PLANNING COMMISSION MEETING

LOCATION: TOWNSHIP ANNEX, 7527 HIGHLAND ROAD, WHITE LAKE, MI 48383
THURSDAY, SEPTEMBER 05, 2024 – 6:30 PM

**WHITE LAKE TOWNSHIP
PLANNING COMMISSION
AUGUST 15, 2024**

SCALE: 1" = 5' (VERT)
1" = 50' (HORIZ)

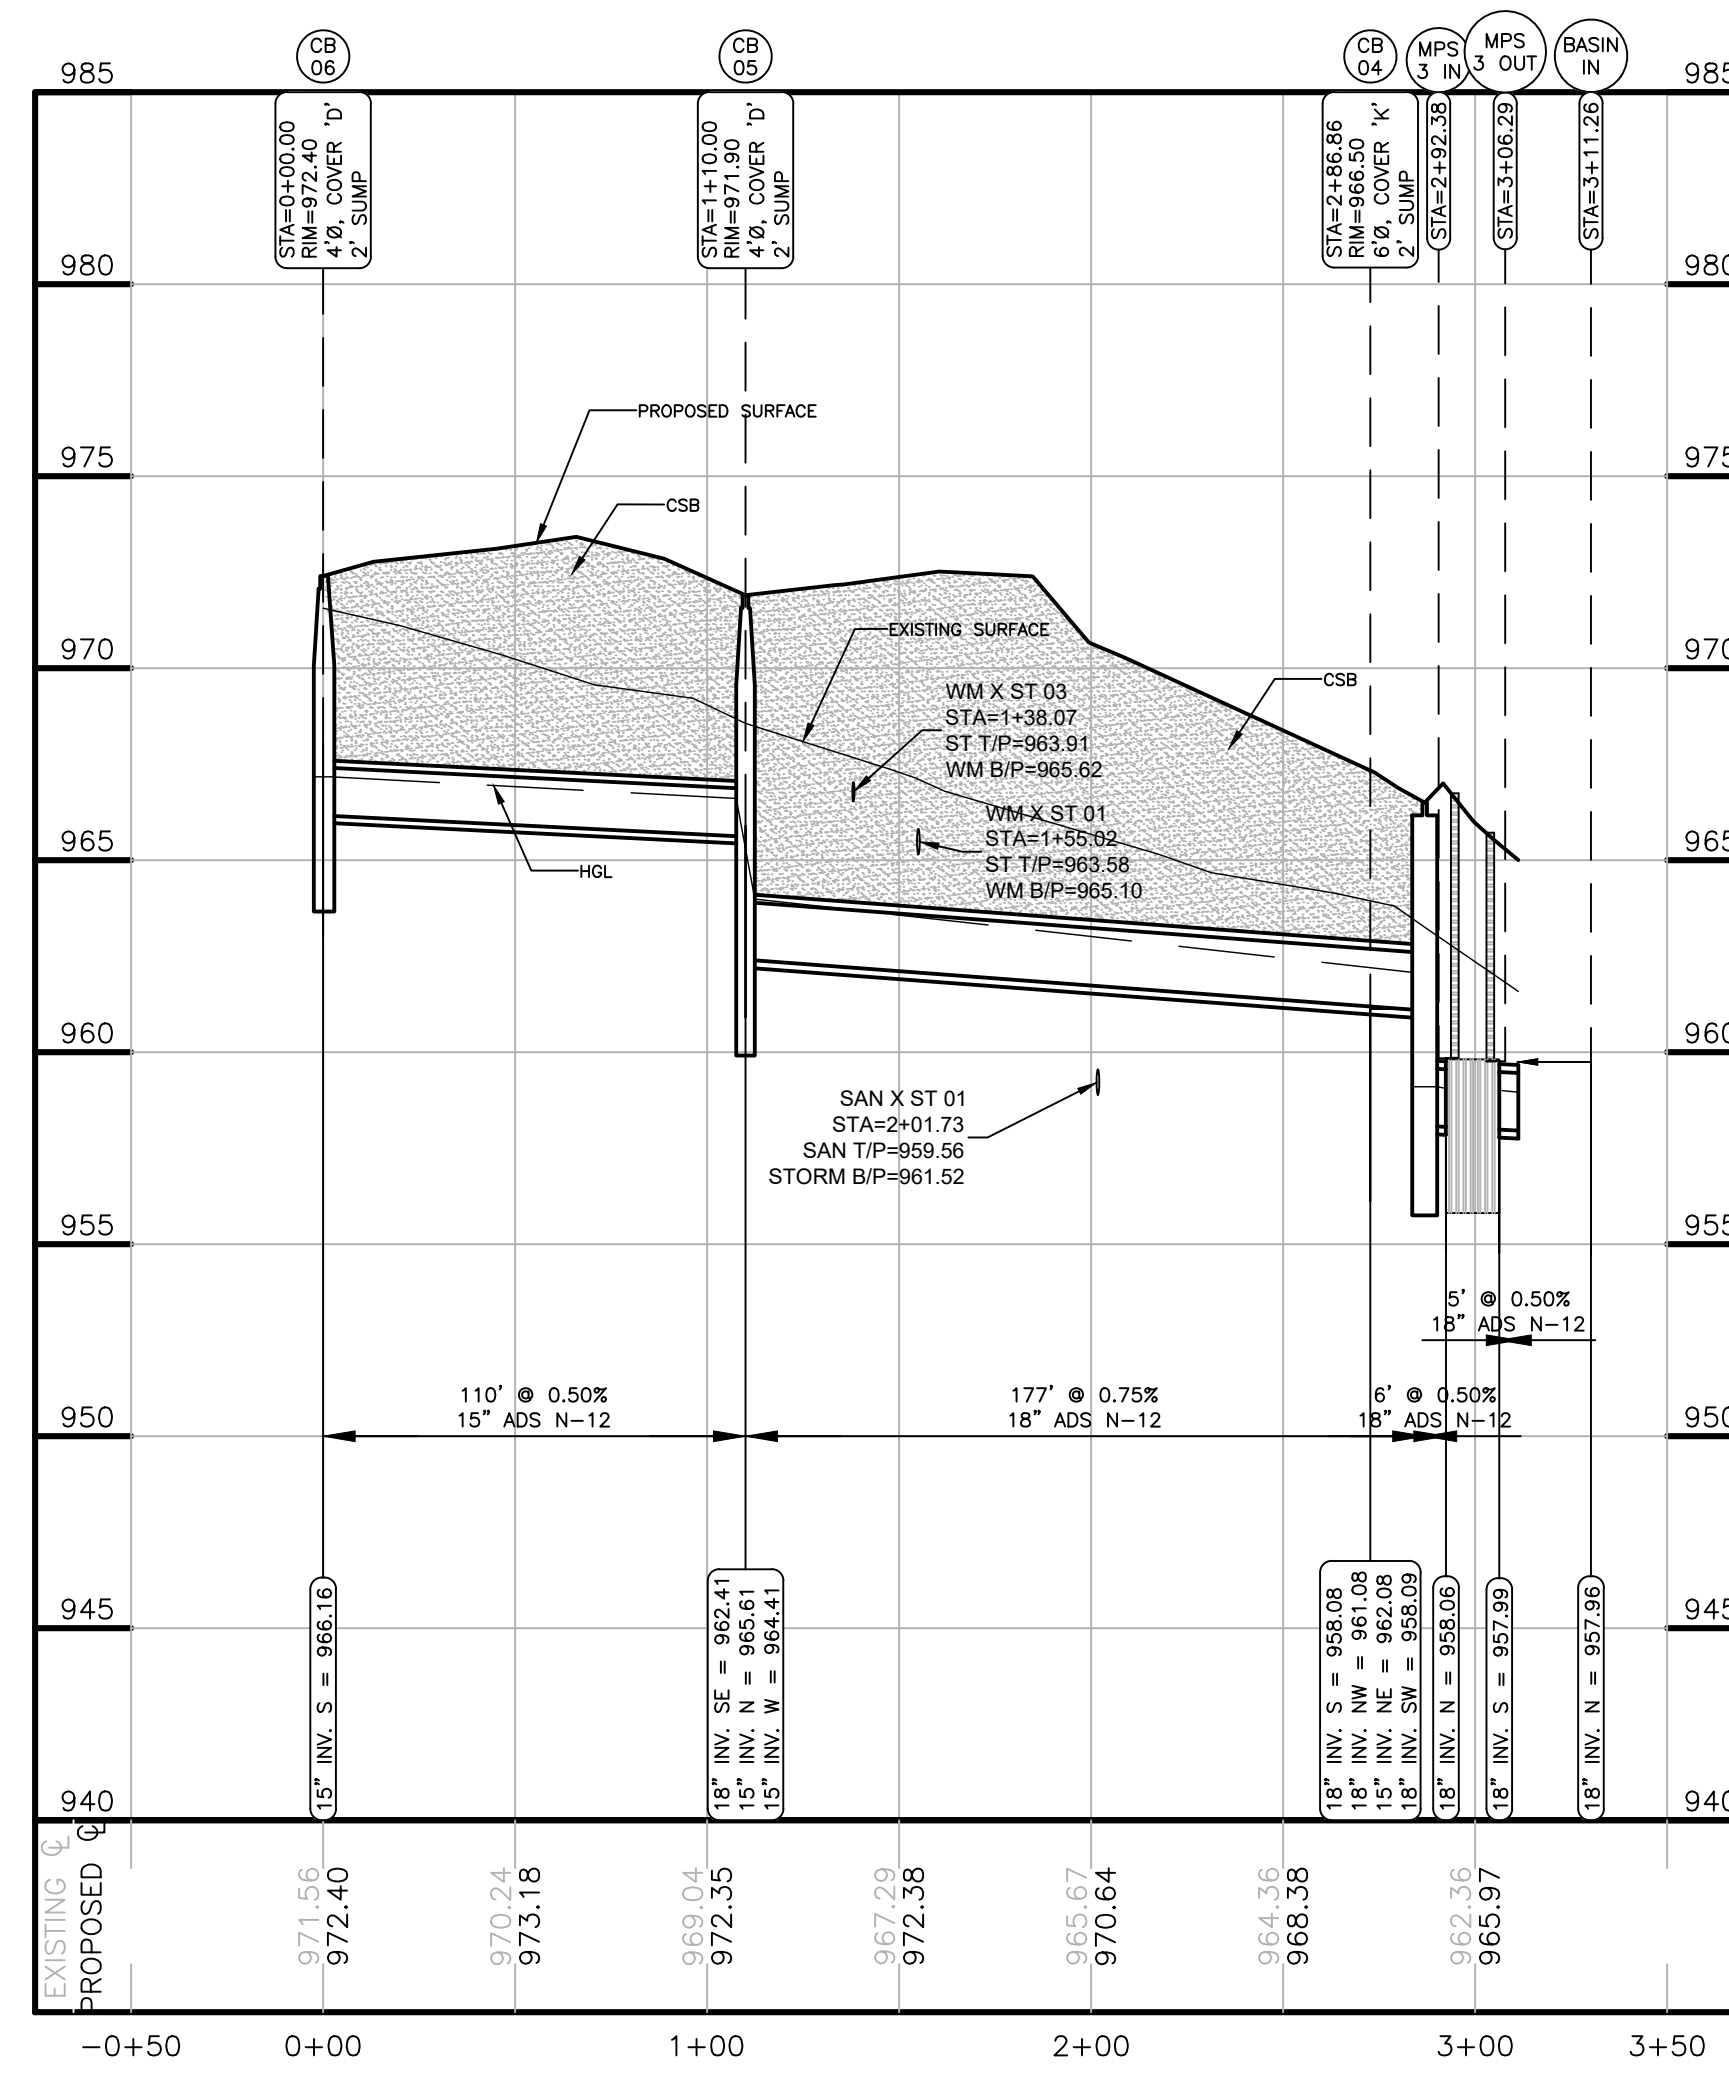
16. *Sheet 10 -Utility plan inset- Move FES A label for readability on plan.* **Comment addressed. Label has been moved.**
17. *Sheet 10- CB07- Rim elevation is incorrect. Please match that shown on grading plan and storm sewer pipe sizing calculations. That rim elevation on the grading plan and storm calculations appears to be the correct one.* **Comment addressed. Rim elevation has been corrected.**

18. *Sheet 10-CB07-CB06-Provide/show CSB near CB07 on the profile (in the area where 'Existing Surface' arrow is shown). CSB is required within the influence of pavement. Comment addressed. CSB has now been shown in this area.*

19. *Sheet 10- Label CB06 additionally as stormwater pretreatment unit. Comment addressed. Pretreatment unit has now been shown on profile.*
20. *Sheet 10- CB12-CB11- Show electric crossing. Comment addressed. Electric crossing is now shown.*

21. *Sheet 10-CB11-CB10- WM X ST 02-A minimum of 18" vertical separation is required between storm and watermain. Currently 12" of vertical separation is shown. In addition, label on crossing is incorrect and is labeled as SAN B/P. Please relabel to WM B/P. Comment addressed. 18" minimum vertical separation is now shown, and label has been corrected.*

22. *Sheet 10-FES 14-MH 14A- Please investigate whether it is possible is lessen the pipe slope to < or = 3.62% maximum pipe grade for this run of pipe. It is understood that due to steep grade constraints on the site that this may not be feasible. In addition, please review the 8.00% grades on pipe runs FES18-MH16-MH19 for the same. Comment addressed. Severe pipe run slopes have been reduced.*

23. *Sheet 10- OCS 2- A minimum of 3' sump is required for this structure. Comment addressed. A 3' sump has been provided.*
24. *Sheet 10-Basin Out – OCS2- Pipe slope calculates to 0.50% and not 0.40% based on provided inverts. Please revise. Comment addressed. Pipe slope has been revised.*

32. Sheet 10-CB04 to MPS 3 IN and MPS 3 OUT to BASIN IN- Shows ADS N-12 as pipe material while Sheet 5 shows ADS SCH 40 for these two runs. Please revise for consistency between sheets.

SHEET NO. 11

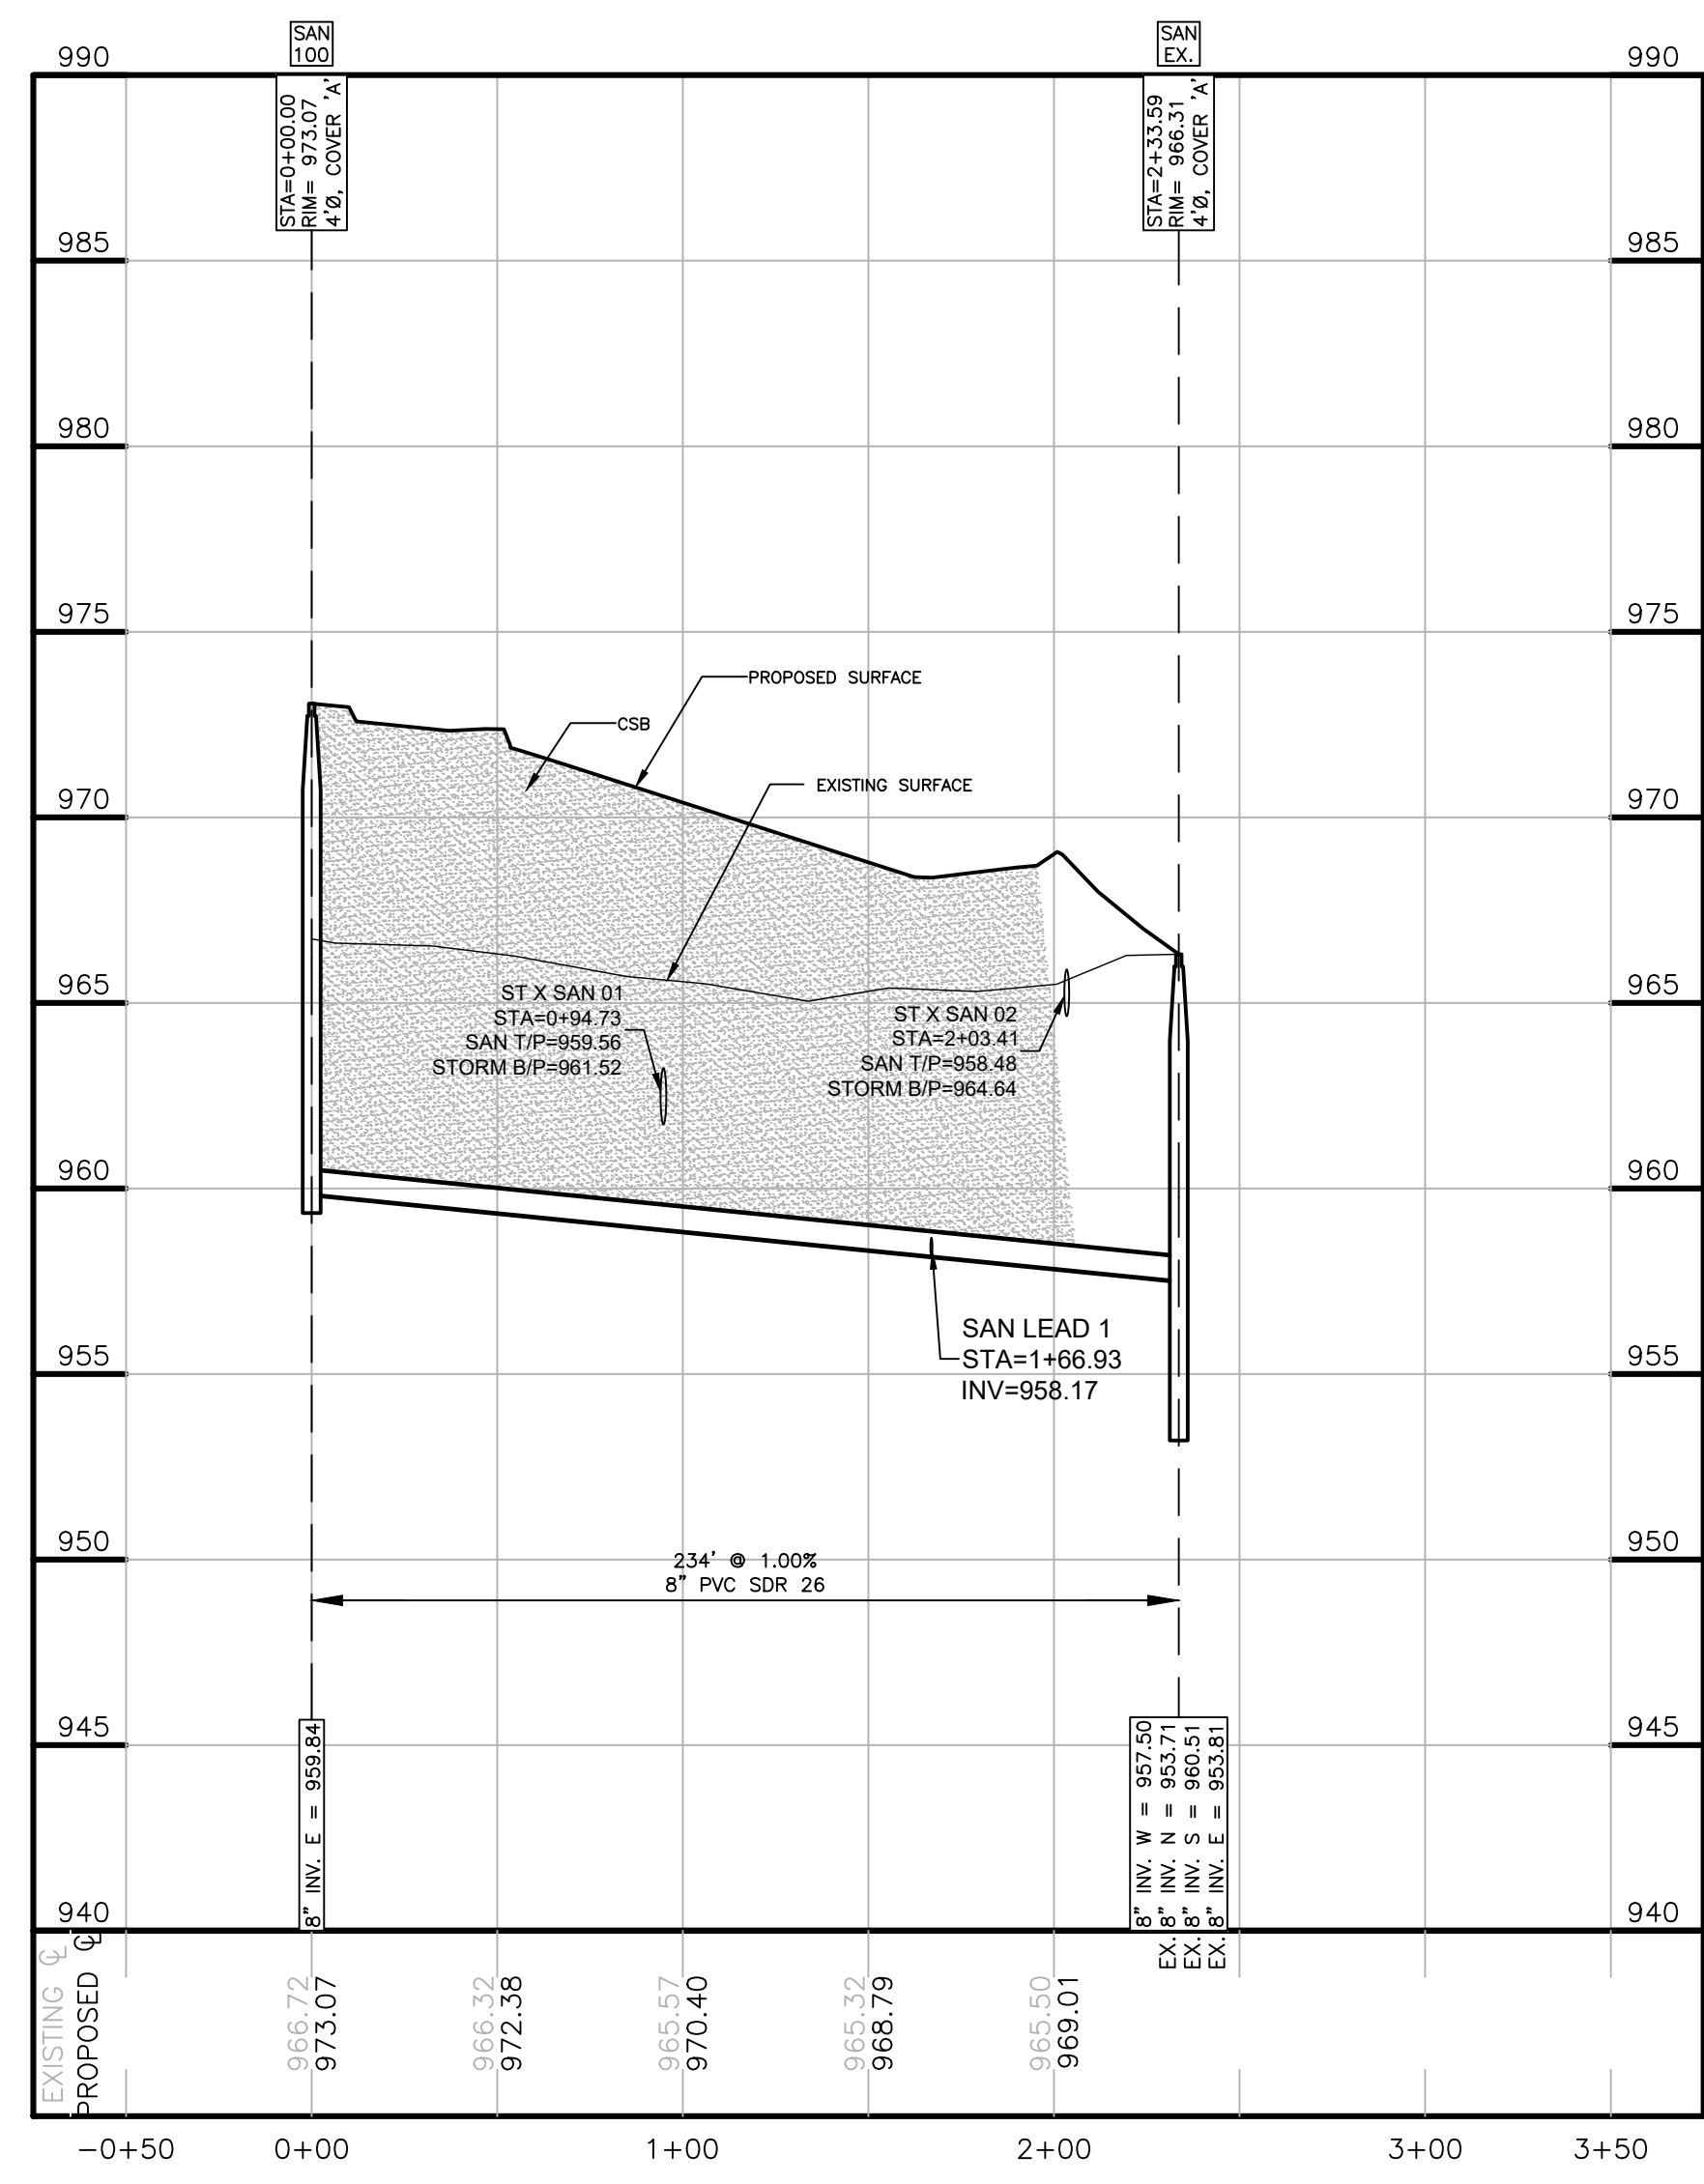
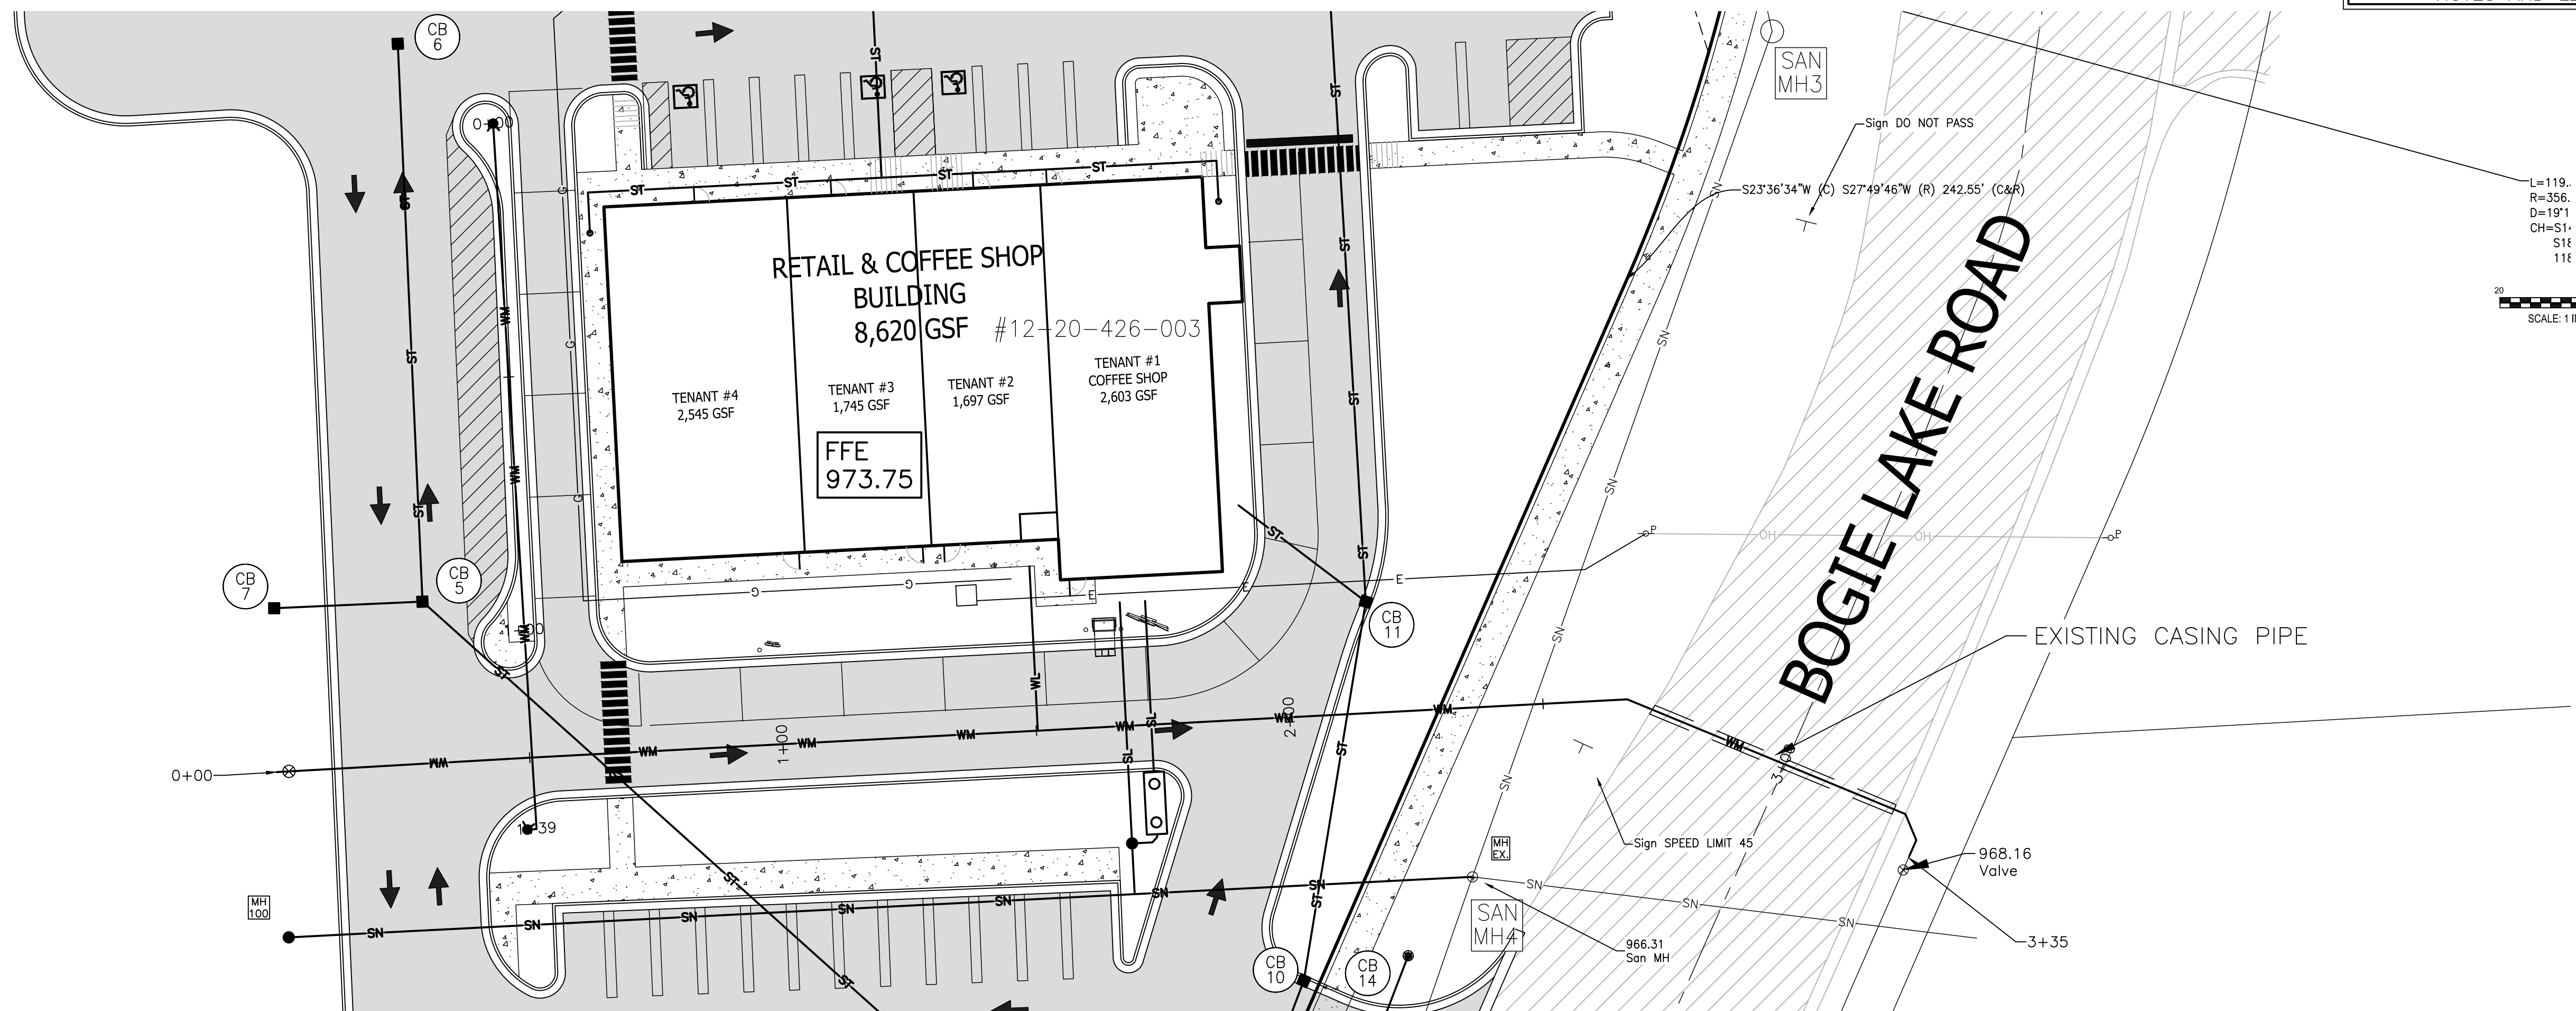
7. *Sheet 11- Profile- Label SAN-SAN MH as Existing. Comment addressed. MH has been relabeled.*
8. *Sheet 11- It is not clear what the three ring shaped items are that are shown directly in the sanitary pipe. Please clarify. Comment addressed. Rings in pipe have been removed.*

9. *Sheet 11- Label the N, S, and E inverts as existing in the SAN-SAN MH. Comment addressed. Inverts have been relabeled as existing.*
10. *Sheet 11- ST X SAN 01-STORM B/P invert shown (961.95) does not match invert of 961.73 on storm sewer profile at crossing between storm sewer structure CB07 and CB 06 on Sheet 10. Please revise as needed. Comment addressed. Inverts now match.*
